## Kemmer T 8S R 24E Section 5 & 6 Tax Lot 700

APP R-87284

alt res apps R-87282 (Reservoir 5) and R-87284 (Reservoir 7) }- James Kemmer --

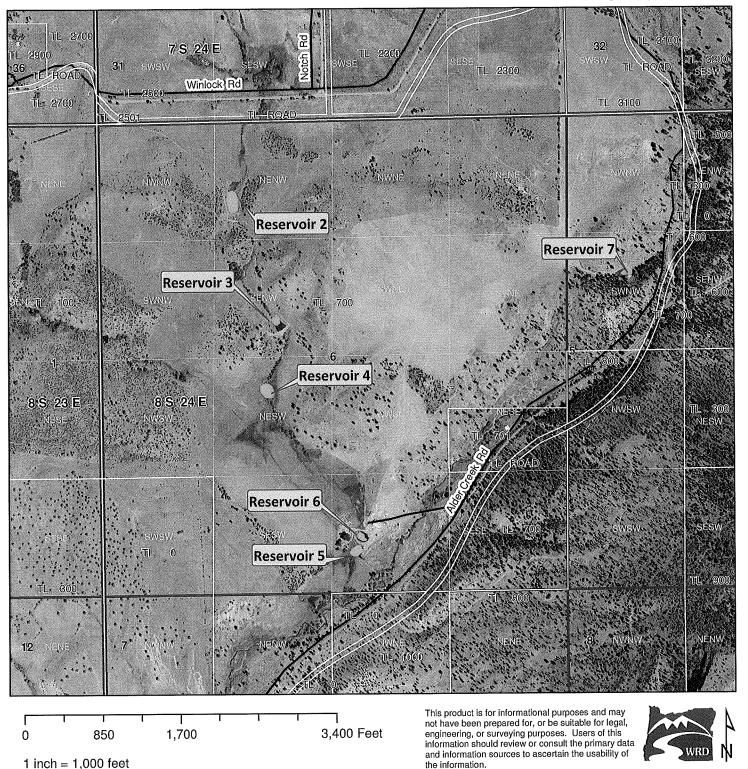
wrong coordinates

= Reservoir 5: SWSE of Section 6 T8S R24E WM; Center of Reservoir- 455 feet North and 2300 feet West from the SE corner of Section 6

= Reservoir 6: SWSE of Section 6 T8S R24E WM; Center of Reservoir- 610 feet North and 2250 feet West from the SE corner of Section 6

= Reservoir 7: SWNW of Section 5 T8S R24E WM; Center of Reservoir- 1710 feet South and 655 feet East from the NE corner of Section 6
